1022 Peddie St Norhill

CERTIFICATE OF APPROPRIATENESS

Proposal: Alteration – Windows:

Recommendation: Denial

EXISTING WINDOWS

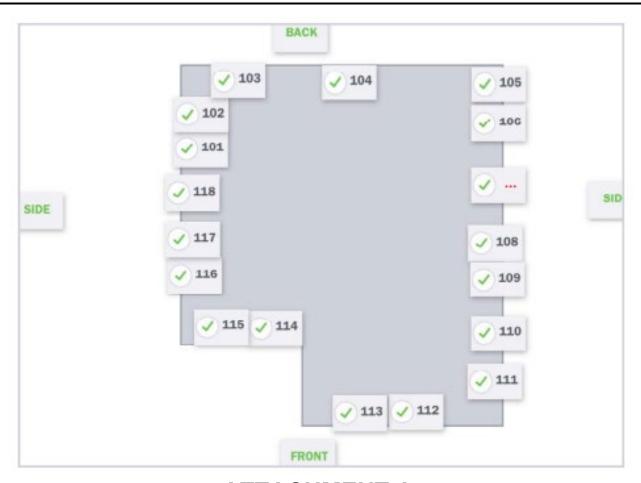
S	D	NA		S - satisfies D - does not satisfy NA - not applicable
			(1)	The proposed activity must retain and preserve the historical character of the property; The existing windows are in need of repair, thus preserving the character of the property.

(4)	The proposed activity must preserve the distinguishing qualities or character of the building, structure, object or site and its environment; By replacing windows that are in good condition, the windows are not being preserved.

(9)	The proposed design for any exterior alterations or addition must not destroy significant historical, architectural, archaeological or cultural material, including but not limited to siding, windows, doors and porch elements; By removing the existing windows, would indeed be destroying significant historic material
\boxtimes			(10)	The proposed alteration or addition must be compatible with the massing, size, scale material and character of the property and the context area; and
